RFP 36E77618R0053 RENOVATE 5TH FLOOR SURGERY TECHNICAL QUESTIONS AND VA RESPONSE TRACKING SHEET

Addendum No. 2
Date: 5-01-2018

Project: VA Healthcare System, Sioux Falls, SD.
Renovate 5th Floor Surgery
438-15-201

DRAWING NO.: ASD-1

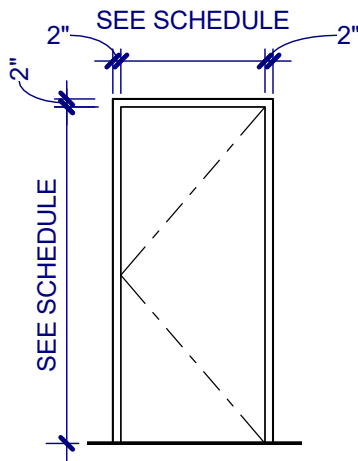
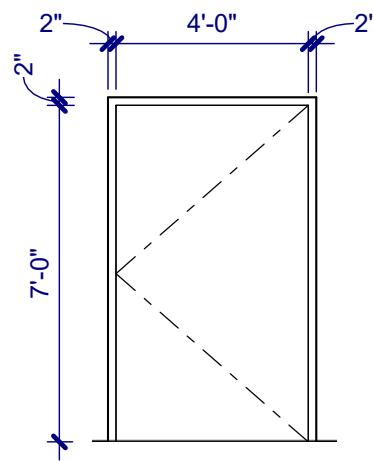
- A. Door Frame Types C and E shall not have a sidelight. Revise Door Frame Types C and E as shown on attached Supplemental Drawing ASD-1.
- B. In the Door Schedule remove the note regarding a 10 inch sidelight from Door 518 and Door 519.
